Public Comments

2020 ANSI Z765 Square Footage: Method for Calculating

June 3, 2020

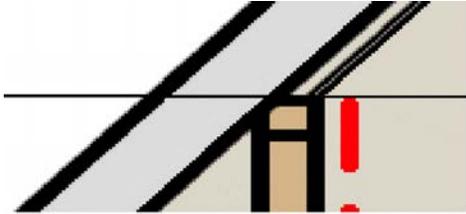
PC 38 – Section 3.4 Openings to the Floor Below		10/9/2019
Submitter:	Brian Juedes	
Requested Action:	Revise the calculation of area at stairs so that the area of both stair treads and landings is included in the finished area of the floor from which the stairs ascend .	
Proposed Change:	<p>Delete the words “proceeding to the floor below”, change the word “descend” to “ascend” and delete the words “not to exceed the area of the opening in the floor”.</p> <p><i>However, the area of both stair treads and landings proceeding to the floor below is included in the finished area of the floor from which the stairs descend ascend, not to exceed the area of the opening in the floor.</i></p>	
Reason:	<p>To bring the ANSI Z765 finished square footage calculation in alignment with standard of practice calculation for livable area from Architectural firms working in production housing.</p> <p>Under ANSI Z765-2013 on a simple 2-story home without a basement, the area of the stair treads and landings is included on the second floor AND the first floor. This varies from current and historical architectural standard of practice. This creates complexity for the homebuilding industry and confusion for consumers.</p> <p>Under the proposed change, the stair calculation could be moved from under “Openings to the Floor Below” to its own “Stairs” heading for added clarity.</p>
